## Item H-4

PUBLIC HEARING: Consider a recommendation for a Specific Use Permit (SUP) for an approximately 4,272 square foot detached accessory dwelling unit before constructing a new home, located on approximately 3.57-acres, on the north side of Simmons Drive, approximately one thousand four hundred feet (1,400') east of the Simmons Drive and Rufe Snow Drive intersection, at 1021 Simmons Drive, being Lot 13R, Block 1, Rolling Oaks Estates, and zoned SF-36 (Single Family Residential – 36,000 square foot minimum). Trent and Mary Petty, owners. Greg Wright, Providential Land Development, LP, applicant. (SUP-17-0020)

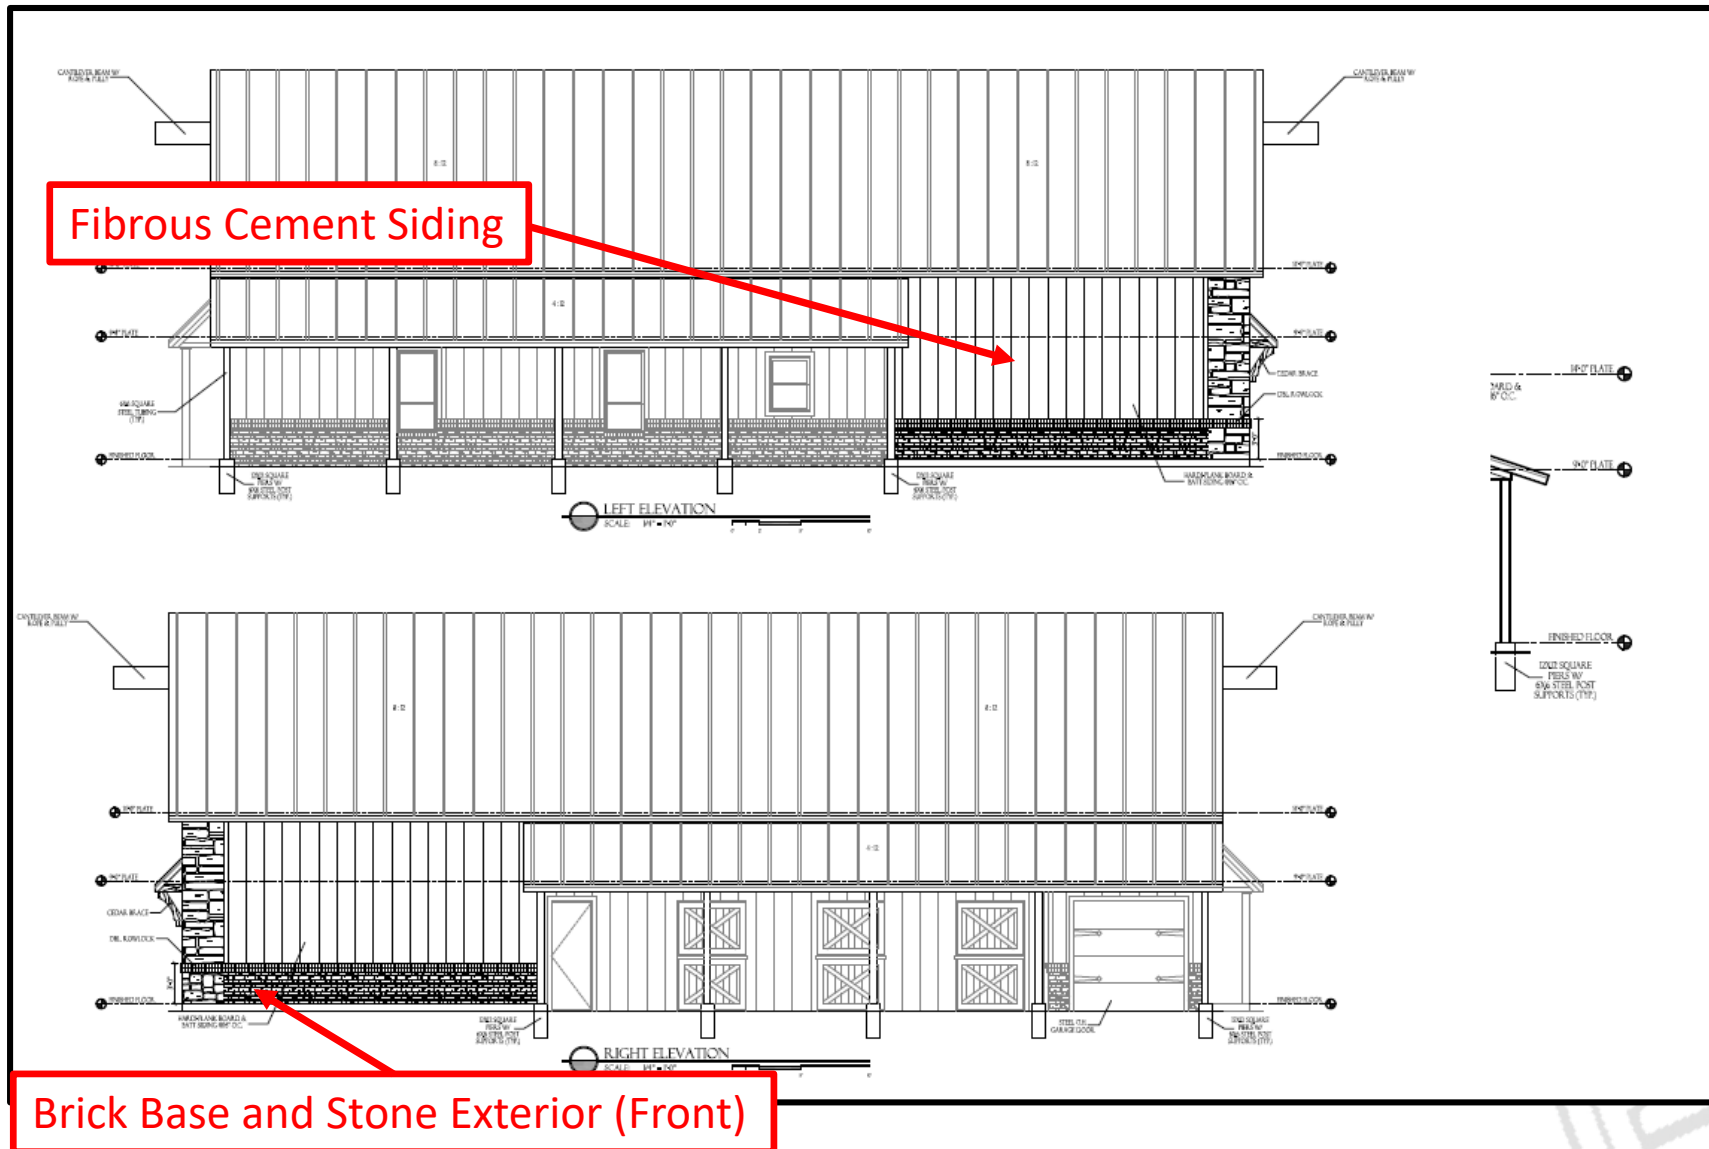
UDC Section 8.10 (A.9) states that the average maximum height for an accessory building is fifteen feet (15') unless approved by a Specific Use Permit.

Average building height is 20'.

3. A variance to allow the building height to exceed fifteen feet (15').

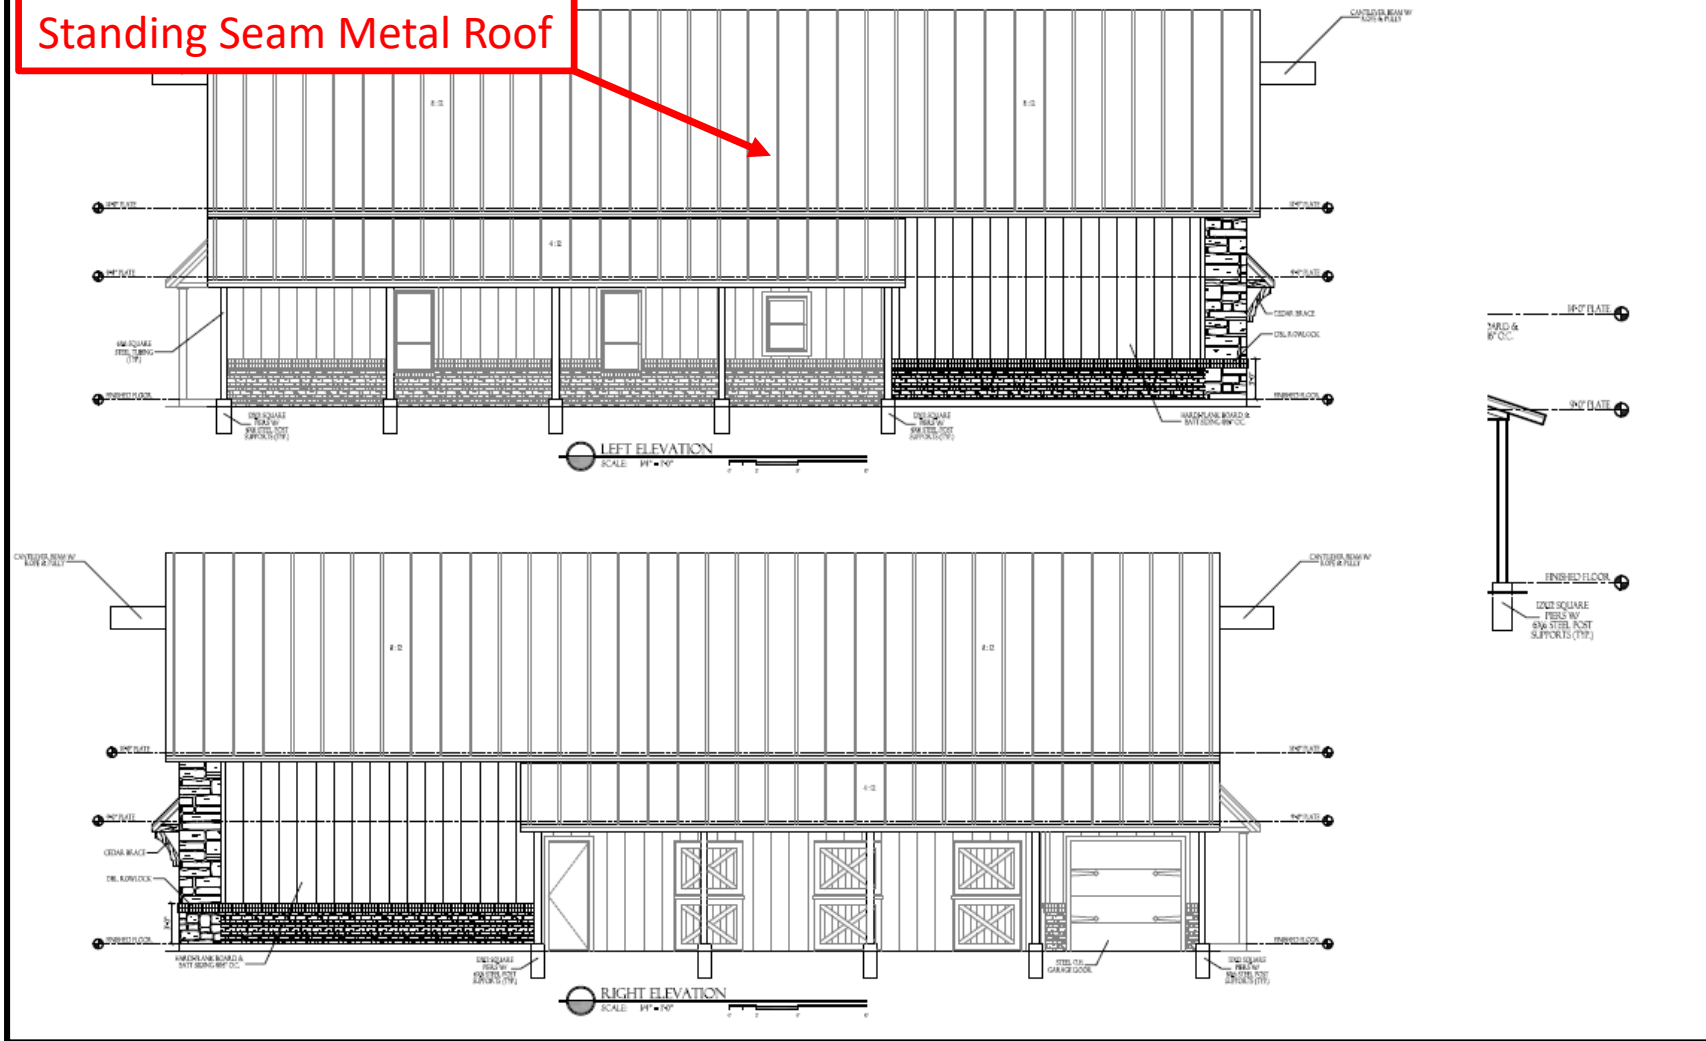
UDC Section 8.10 (A.3) states that accessory buildings shall be complementary to the main structure, constructed of brick or stone or of the same material as the main structure.

- (100%) of the front elevation will be stone with a brick trim.
- The sides and rear have three-foot (3') high brick base with the remainder a fibrous cement siding.

4. A variance to waive the eighty percent (80%) masonry requirement as shown in "Exhibit A."
